MIL ON With DTC P059A71

YEAR(S)	MODEL(S)	ADDITIONAL INFORMATION
2022	Tundra

Some 2022 model year Tundra vehicles may exhibit a MIL ON condition with the Diagnostic Trouble Code (DTC) P059A71 (Active Grille Air Shutter “A” Actuator Stuck) present. The Engine Control Module (ECM) (SAE term: Powertrain Control Module/PCM) logic has been modified to reduce the possibility of this condition. Follow the Repair Procedure in this bulletin to address this condition.

Figure 1. Location of Authorized Modifications Label on 2022 Tundra

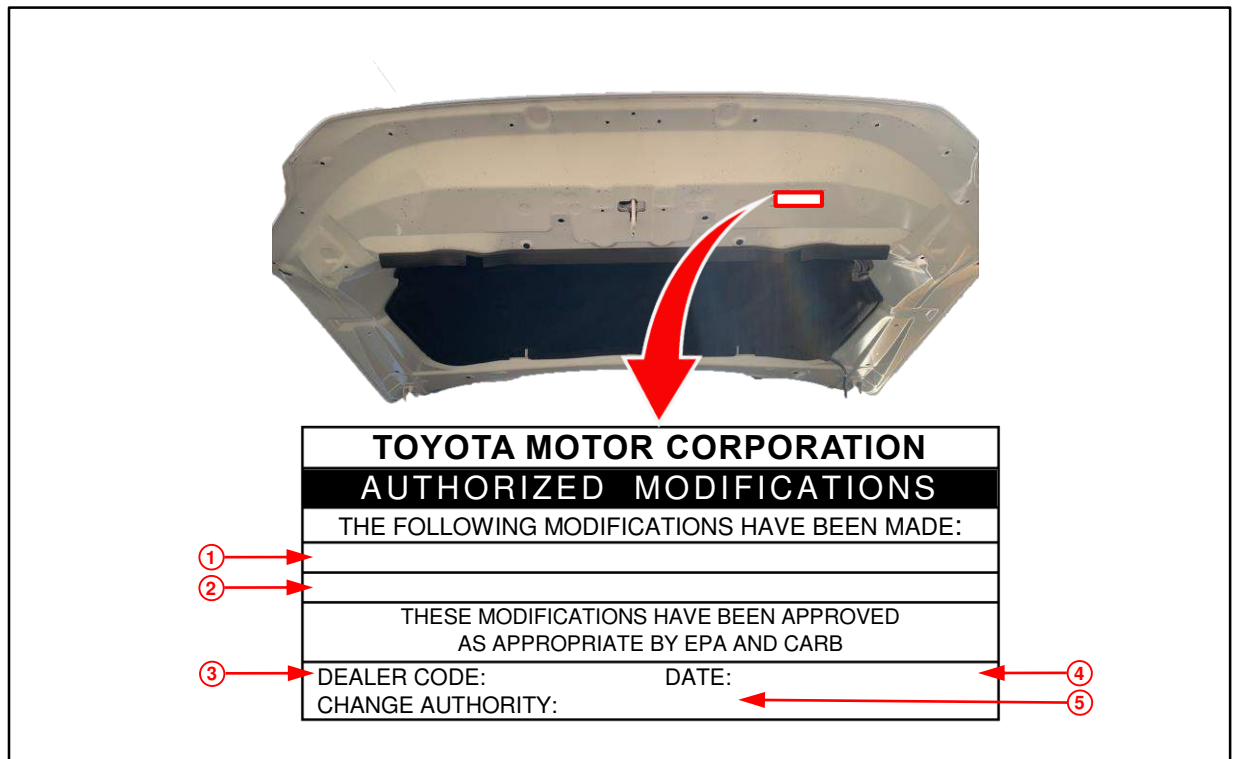
2. Use Techstream to confirm if the ECM (PCM) calibration has been updated and check for the Authorized Modifications Label affixed to the vehicle in the location shown below.

4. Prepare and install the Authorized Modifications Label.
 - A. Using a permanent marker, enter the following information on the label:
 - ECM (PCM) part number [*Refer to the **Parts Information** section for the **NEW PART NUMBER***]
 - Calibration ID(s) [*Refer to the **Calibration Information** section for the **NEW CALIBRATION ID***]
 - Dealer Code
 - Repair Date
 - Change Authority [***This bulletin number***]
 - B. Install the Authorized Modifications Label onto the vehicle at the location shown in Figure 1. The Authorized Modifications Label is available through the MDC, P/N 00451-00001-LBL.
5. Test-drive the vehicle to confirm proper operation.
